**Government of India
Ministry of Railways
Research Designs & Standards Organisation
Manak Nagar , Lucknow – 226011**

MODIFICATION SHEET NO. RDSO/WAM4/189 (Amentment-1)

To provide capacitors across U, V, & W terminals of MCP and Arno convertors.

1	FIG.2 OF MODIFICATION NO. WAM4–189 OF 24.5.95 DELETED		DSC 3		
ALT.	DESCRIPTION		AUTHORITY	MANUAL	DATE
REF :		SCALE : NTS	APPROVED		
PROVISION OF CAPACITORS BETWEEN U,V,W TERMINALS AND EARTH ON MCP,S AND ARNO CONVERTOR					
R.D.S.O. ELECT. DTE.			SKEL 4345 ALT 1

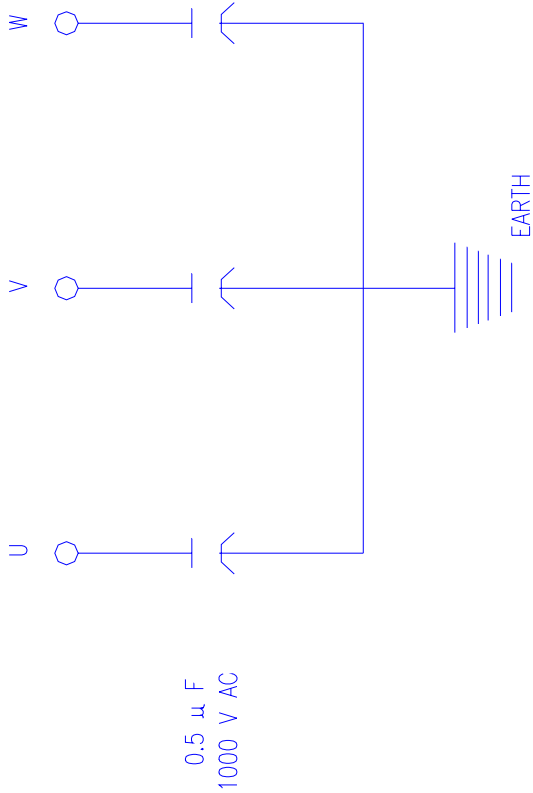
Railways have reported the failure of stator winding of MCP and Arno convertors. Detailed investigation into the failure revealed that one of the cause may be due to the presence of switching `on` and `OFF` surges. In order to arrest the failure of Stator winding, this modification is being issued.

5.1 Provide one number each of capacitor of 0.5 microfarad, 1000 V AC across U, V & W terminals and earth of MCP and Arno convertors as shown in drawing SK. EL. 4346 Alt (1).

5.2 The capacitors should be fixed on a bakelite board and mounted in a transparent plastic box and 4 terminals should be brought out for connections between U, V & W and earth.

5.3 Mount the plastic box containing the capacitors in the frame of motor compressor set and at suitable place near Arno convertors.

5.4 Mounting bolt for fixing the box should be strong enough to resist vibration encountered in service.

5.5 Mounting should not infringe with the parts available in surrounding, e.g., the motor compressor set and Arno convertor.
